**STATE OF DELAWARE
EXECUTIVE DEPARTMENT
OFFICE OF STATE PLANNING COORDINATION**

RE: PLUS review – 2012-12-02 – Bay Forest Club

Figure 1: NRCS soil survey mapping update in the vicinity of the proposed construction.

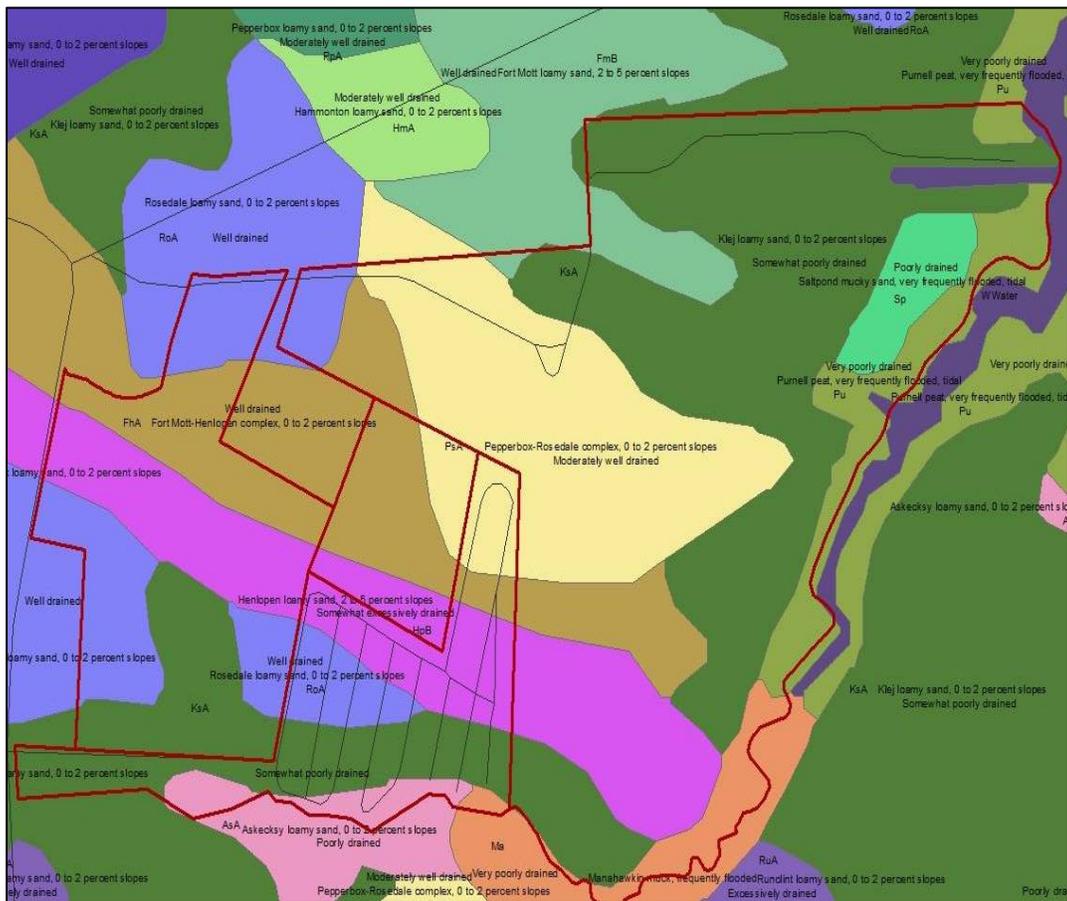
- Based on the soil survey mapping, Klej and Askecksy, Manahawkin, Purnell and Salt pond mucky sand are the soil mapping units likely to have the most limitations for development on this site. Klej is a somewhat poorly-drained mapping unit that occurs in transitional zones between wetland and upland environments; consequently, this soil mapping unit may or may not be hydric. Askecksy, Manahawkin, Purnell and Salt pond mucky sand are poorly to very poorly-drained wetland associated (hydric) soil mapping units with severe limitations for development. (Considered unsuitable for development). DNREC recommends that a certified and licensed soil scientist (ARCPACs certified and Class D licensed) to make a site-specific evaluation of the soils in this area. Please contact the Underground Discharges Branch at 739-9948 for a list of soil scientists.

- The Statewide Wetland Mapping Project (SWMP) often uses the soil survey as the basis for mapping and delineating wetlands. The presence of a hydric soil is one of three parameters that must be met in order to meet jurisdictional wetland requirements (as specified by the USACOE). The other parameters are hydrophytic vegetation and hydrology. Thus the presence of hydric soils is a correlate with wetland presence. Building on hydric soils is likely to increase the potential for on-site and off-site flooding potentials (See figure 1). DNREC recommends avoiding those areas containing hydric or potentially hydric soil mapping units.
